**BEFORE THE CALIFORNIA ENERGY COMMISSION
OF THE STATE OF CALIFORNIA**

Docket No. 12-IEP-1D

Preparation of the 2012 Integrated Energy
Policy Report (2012 IEPR)

**COMMENTS OF THE ENERGY PRODUCERS AND USERS
COALITION AND THE COGENERATION ASSOCIATION OF CALIFORNIA ON
COMBINED HEAT AND POWER**

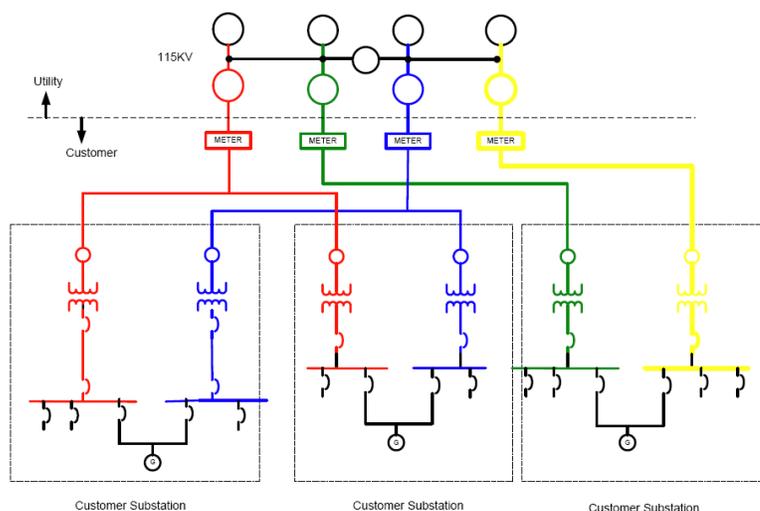
Using the output of a customer-owned CHP facility is straightforward in most circumstances, allowing the utility to measure exports or imports on a net basis at a single site-boundary meter. In some cases, however, CHP configuration may differ as a result of historical configurations or the cost-effectiveness of interconnection solutions. Consider, for example, a large industrial facility with four lines between load and generation and the point of interconnection. Two of the lines may have net generation, while the remaining two may have net load. The following schematic depicts this problem:

In the diagram above, there is no single site-boundary meter. Instead, the four lines serving the facility, which may have net load or generation, are separately metered by the utility using four separate meters in the same location. The meters are within a few feet, as depicted below.

It would seem logical for the utility to net the four meters to determine a net import or export from the industrial site. Instead, however, a utility has taken the position that any such netting would represent “retail wheeling” and has refused to net the meters. As a result, the customer must export generation that it could be using on site, while being forced to simultaneously purchase electricity from the utility in an amount roughly equal to the exported generation. California policy should provide that, regardless of the metering configuration, a utility should permit the customer to net all load and generation at a single site.
